April 2017
FL732A
NHSTA #17V-124
Transport Canada #17-130

Subject: Western Star Aluminum Air Tanks

**Models Affected: Specific Western Star 4900 model vehicles
manufactured March 3, 2014, through January 31, 2017,
built with triple compartment aluminum air tanks.**

Fig. 1, Air Reservoir Installation

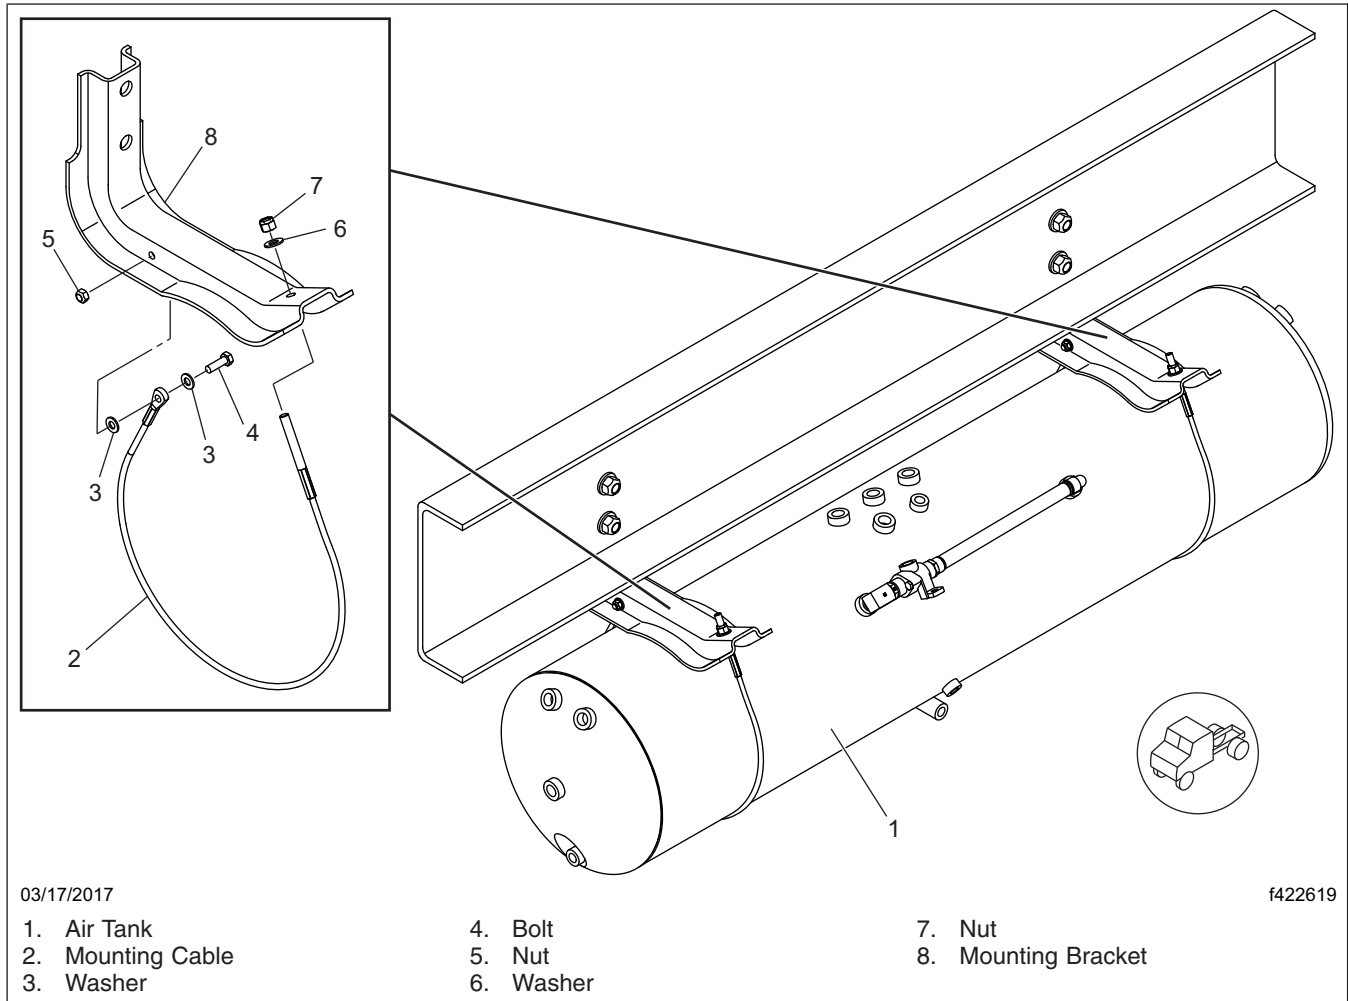
Certain triple compartment air tanks may experience weld separation, which could cause a rapid loss of air pressure without warning. A sudden loss of air pressure may result in a reduction of braking ability or application of the park brakes, potentially increasing the risk of a crash.

The aluminum air tanks will be replaced with steel triple compartment air tanks.

4. Mark or tag all reservoir air lines, couplers, and valves for later assembly, then disconnect the components. Cap the exposed ports tightly to keep out contaminants.
5. Remove the reservoir, as follows. See [Fig. 1](#).
 - 5.1 Remove and discard the mounting cable nuts.
 - 5.2 Remove and discard the mounting cables.
 - 5.3 Remove and discard the reservoir.

8. If there is sufficient work space, place the new reservoir in the mounting bracket, then install the new mounting cables and new fasteners from the kit.

- 8.1 Install the mounting cable eye end bolt and nut finger tight.
- 8.2 Install the threaded end nut finger tight.
- 8.3 Tighten the mounting cable eye end nut 20 lbf·ft (27 N·m).
- 8.4 Tighten the threaded end nut 20 lbf·ft (27 N·m).
